Object: Creation variant "Fast 5260"

Hereby, we declare that the router "Fast 5260" is a variant of the router "F@st 5260CV". This variant is created by removing e-SATA interface and one USB interface. The radio equipment's and the software of the variant "Fast 5260" are the same as for the reference product "F@st 5260CV".

Reference F@st 5260CV FCC ID : VW3FAST5260CV	Variant Fast 5260 FCC ID : VW3FAST5260
---	---

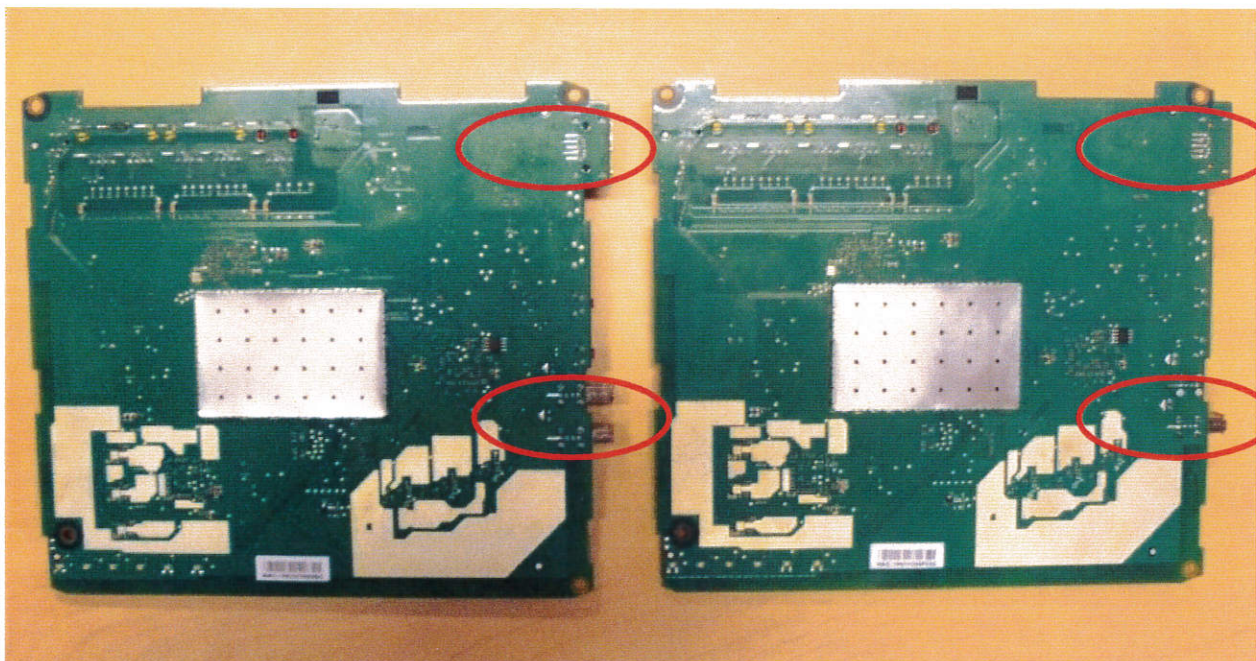
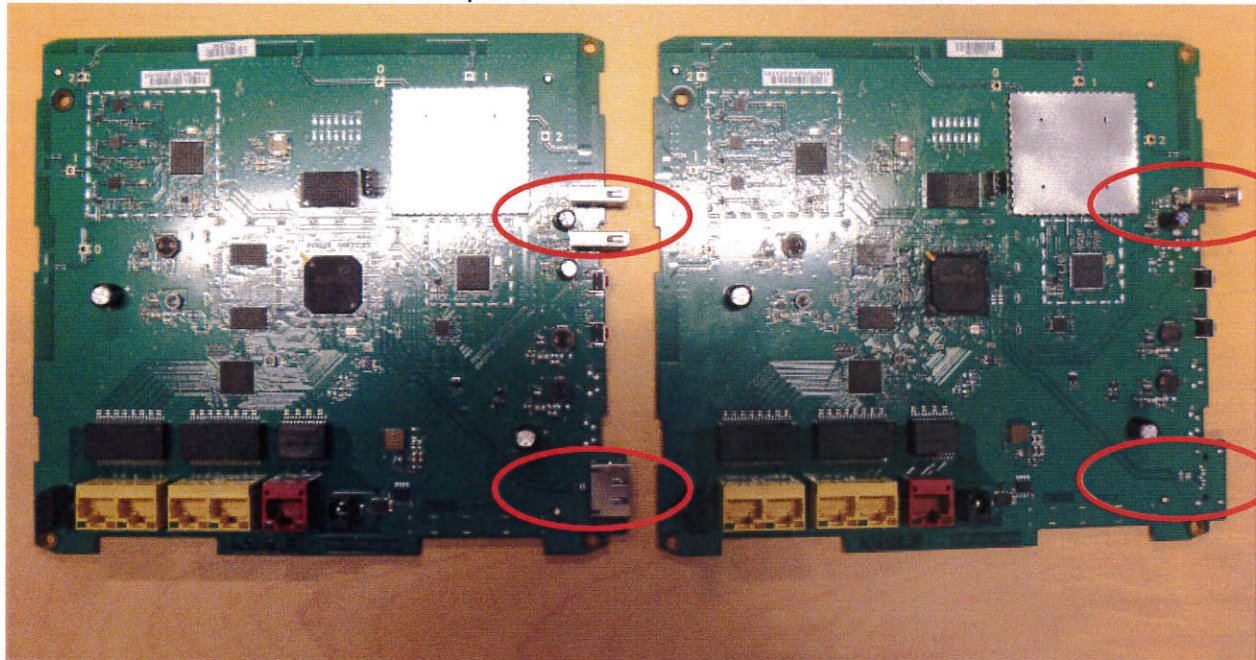
Removal of connectors and components for e-SATA and one USB interfaces

List and location of removed components

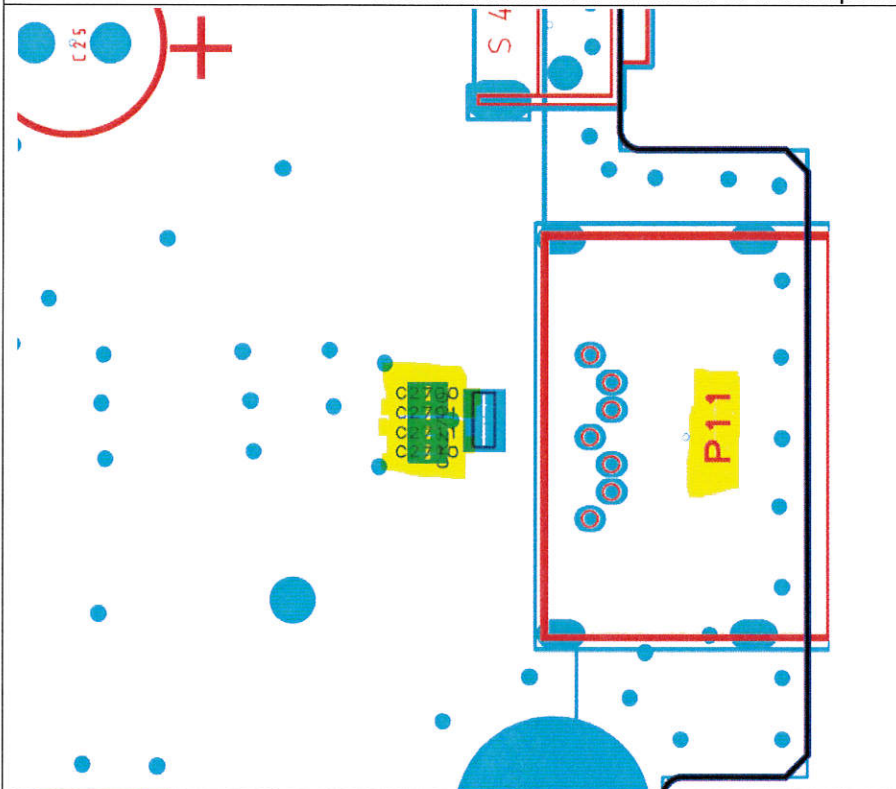
Components in yellow color are removed

- P9
- P11
- C1041
- C1043
- C2700
- C2701
- C2710
- C2711
- L1040
- R1001
- R1003
- R1040
- MX1040
